PRODUCT CHANGE NOTICE

PCN Number: 2023-PCH-02

HAS132UF000002Z

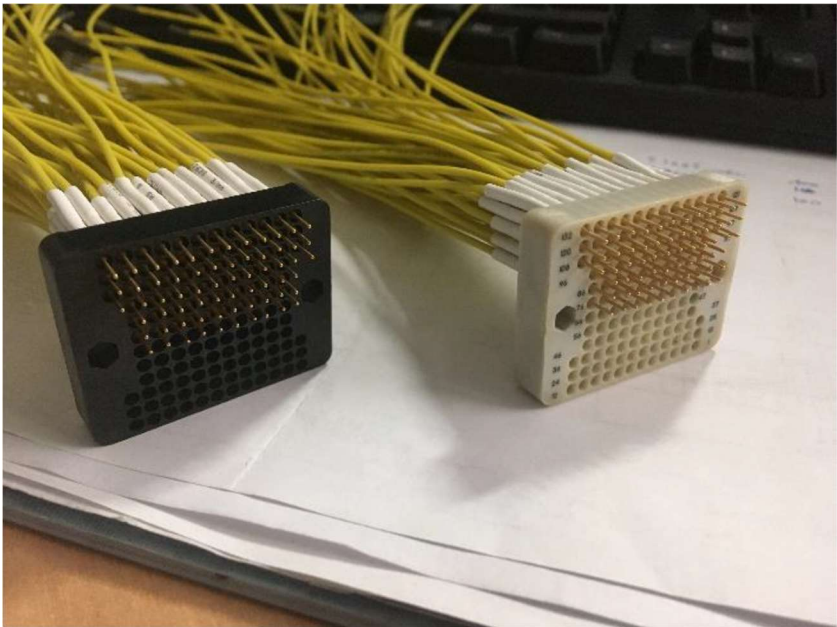
The housing material has changed from Fortron 1140L6 black to Fortron 1140L4 Natural.

This is due to a change in the in process to laser mark the housing as shown below. The material electrical properties have not changed.
